McLaren Speedtail – Coolant Replacement

Bulletin type:	Service Campaign
Reference number:	N/A
Campaign reference:	SCB 23 L 001
Attention:	Retailer Aftersales Managers, Retailer Service Managers, Retailer Service Advisors, Retailer Technicians
Affected vehicles:	McLaren Speedtail
Situation:	Replacement of the current G48 coolant for G64 coolant.
Procedure:	Proactively invite customers using the attached letter. Action affected vehicles on first opportunity (immediately if already on site or during next Retailer visit if not already on site). Please refer to the information outlined in this document to complete the required work.
Date:	02 April 2025

Image 1: Overview of Coolant Filler area

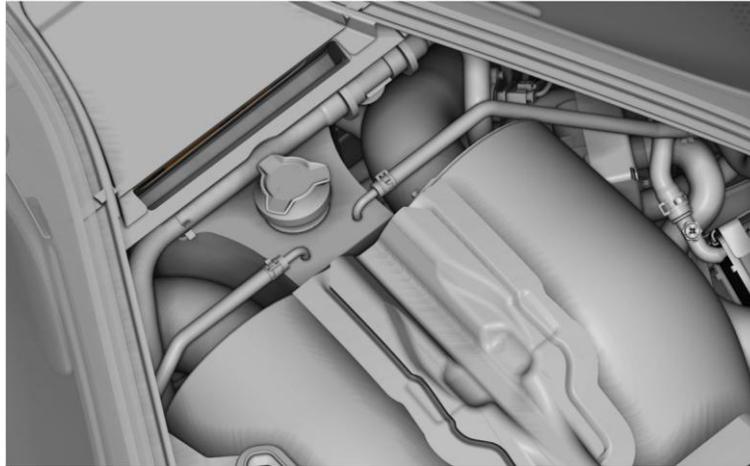
Through continuous product quality monitoring, it has been identified that certain McLaren Speedtail vehicles are stored for long periods of time. During long standing periods, there is a possibility for the current coolant (type G48) to separate, creating a build-up in the high temperature radiator, which could lead to reliability concerns.

To carry out the required work for this Service Campaign to update the vehicle with G64 coolant, follow the McLaren Service Portal (MSP) D031241 “Drain and Fill Coolant/Antifreeze” instruction.

Care Point: Follow all the steps of the MSP procedure to ensure that the old coolant is fully drained.
